Bulletin No.: L03-007  
Release Date: 8/31/06  
Effective Date: Immediately  
Supersedes: N/A  
Completion Date:  
Sept. 15, 2006  
Page: 1 of 2

# SERVICE BULLETIN

Ride Manufacturer: Larson International Inc. Affected Production Dates: All  
Ride Name: HI-ROLLER PORTABLE MODELS AND  
CRAZY TRAIN PORTABLE MODELS

Mandatory Bolt, Nut, and Washer replacement schedule for track sections

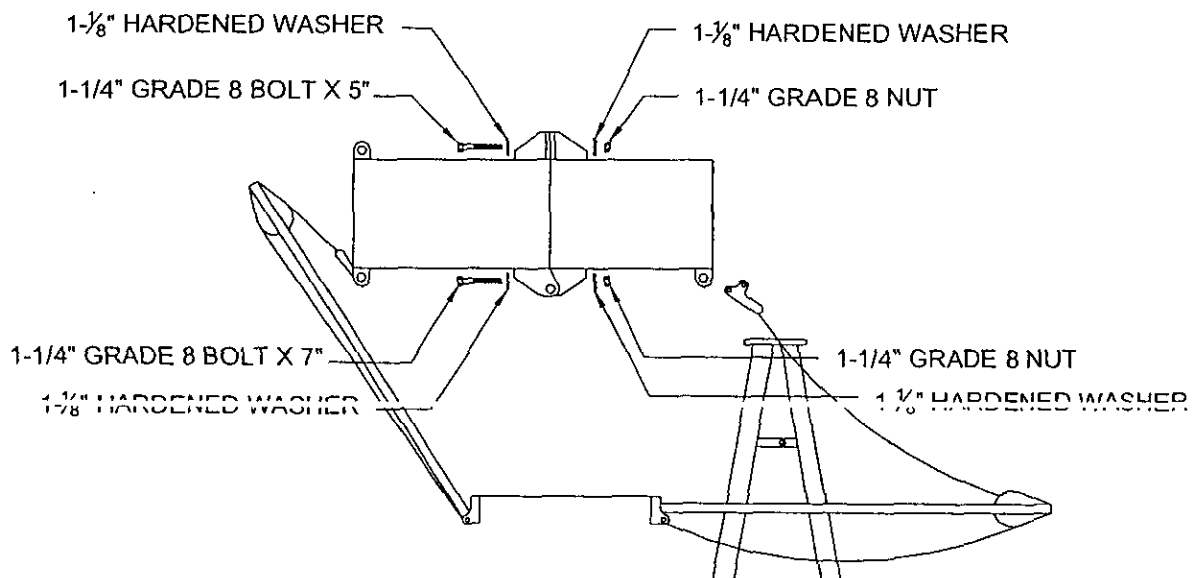
Larson International Inc. has learned that the Grade 8 bolts, Grade 8 nuts, and hardened washers being used to fasten the two track sections together on the Crazy Train and Hi-Roller rides are being replaced with substandard bolts, nuts, and washers. There is reasonable concern that serious personal injury and property damage could result from failure of these fasteners.

1. Remove all ten, 1-1/4" bolts, nuts, and washers currently being used to fasten the two track sections together.
2. Replace with 1-1/4" Grade 8 UNC bolts, Grade 8 UNC nuts, and 1-1/8" hardened washers purchased from Larson International, Inc.

3. All bolts and nuts must be dry torqued to 400 foot pounds with a torque wrench.
4. Proper bolt tension must be checked daily with a torque wrench to 400 foot pounds of torque.

5. All bolts, nuts, and washers must undergo a visual inspection each time the ride is erected checking for corrosion, thread damage, bending and cracking. If any corrosion, thread damage, bending or cracking is seen or if excessive torquing is required to remove the bolts and nuts they must be replaced immediately.

6. All hardware must be purchased from Larson International, Inc. to ensure proper quality, size and grade.
7. All hardware must be initially replaced no later than September 15, 2006. If replacement is not completed by this date the ride must be taken out of service until replacement is complete.

8. The entire set of bolts, nuts, and washers must be replaced annually after initial replacement.
